## DESIGN REVIEW PANEL (DRP)

### RECOMMENDATION ON PLANNING PROPOSAL

**Proposed development:** Causeway Pedestrian and Cyclist Bridge

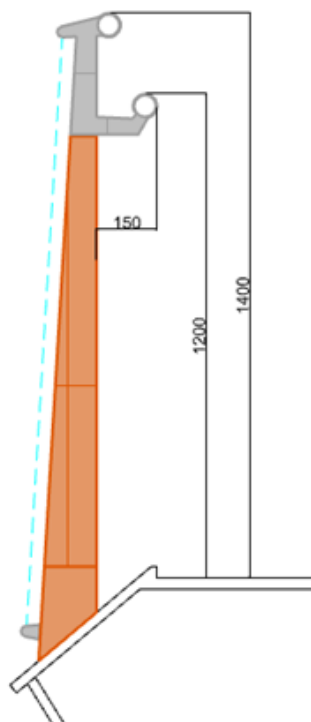
- Staircases look like a basic ‘patterned design’ and not tailored to the unique qualities or intent of the project. All components of the bridge and landing areas each side should have rigor and reflect the masterplan vision and principles.

(CLA Response) – Stair designs have previously been adjusted (widened from 3m to 6m) to better incorporate future McCallum Park user needs, in response to feedback from the Town.
